17_147

68-72 GREAT SOUTH ROAD, POKENO – TRANSPORT PEER REVIEW

Gull New Zealand Limited (the Applicant) propose to develop a 24-hour service station at 68-72 Great South Road, Pokeno. Waikato District Council require a review of the Applicant's transportation assessment report and potential effects, related to transport, of the proposal.

Figure 23: Swept Path of Quad-Axle Semi-Trailer Tanker Right Turn Entry and Exit (from TIA Figure 5)

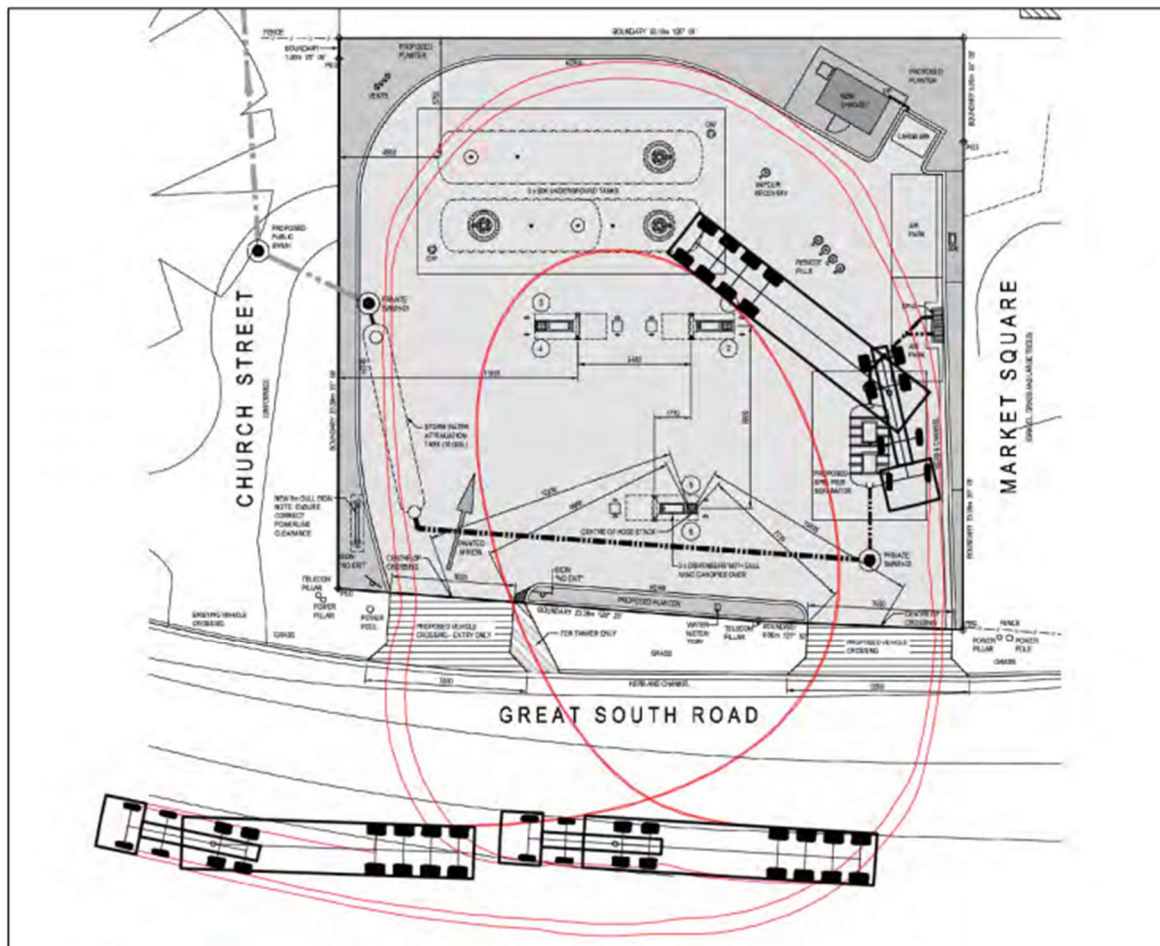
The figure above shows the use of additional widening to Crossing A to allow for the swept path of the tanker entering the site.

Figure 24: Swept Path of Quad-Axle Semi-Trailer Tanker Left Turn Exit (from TIA Figure 5)

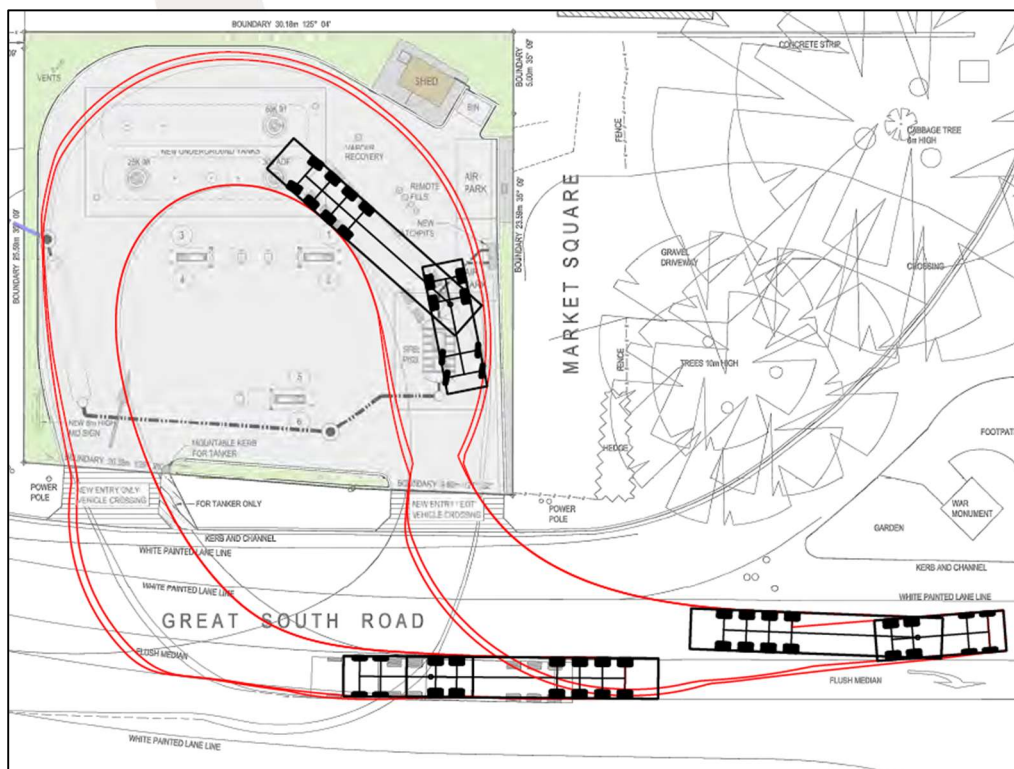
The tanker can turn left to exit the site (as shown in Figure 24) if the flush median space is used. This is acceptable for periods of low traffic flow on Great South Road, but less desirable during peak traffic periods. Turning right to exit the site may be difficult during peak traffic periods and may rely on the courtesy of approaching drivers to allow the tanker to turn onto Great South Road. Clear sight distance to the north is required to minimise the safety risk for drivers.

An option to mitigate turning effect may be to specify right turn entry and right turn exit only for fuel delivery tankers. It is preferable that a tanker arriving from the north can loop around the village and approach the site from the south. Similarly, a tanker departing towards the south should be able to turn right from the site and loop around the village to head south. Consideration needs to be given to the potential effects of tankers circulating around the village to meet the entry and exit restrictions.

Figure 25: Suggested Heavy Vehicle Circulation Route

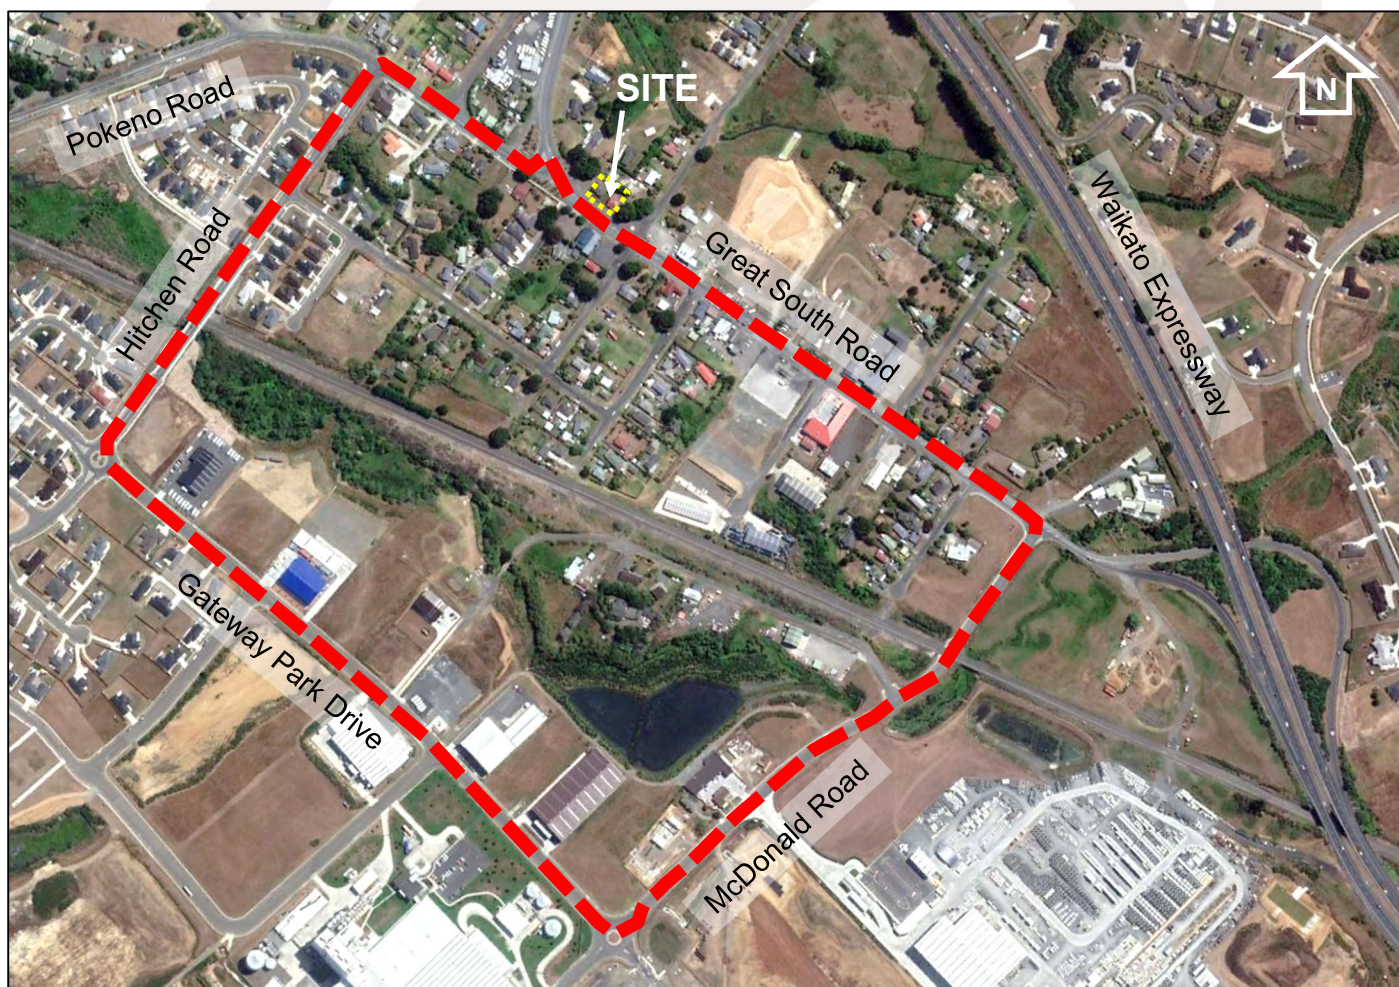
We recommend that the Applicant consult with Waikato District Council to identify a preferred heavy vehicle route for tankers to circulate on that allows them to approach the site from the south and depart to the north, or south. We suggest using the industrial streets as shown in the figure below. These streets and intersections are designed for long and large vehicles, making this a suitable heavy traffic route which avoids residential streets.

Identifying a preferred heavy vehicle circulation route such as shown in Figure 25 (Great South Road, Pokeno Road, Hitchen Road, Gateway Park Drive, McDonald Road), provides a way to manage effects of large vehicles driving along residential streets.
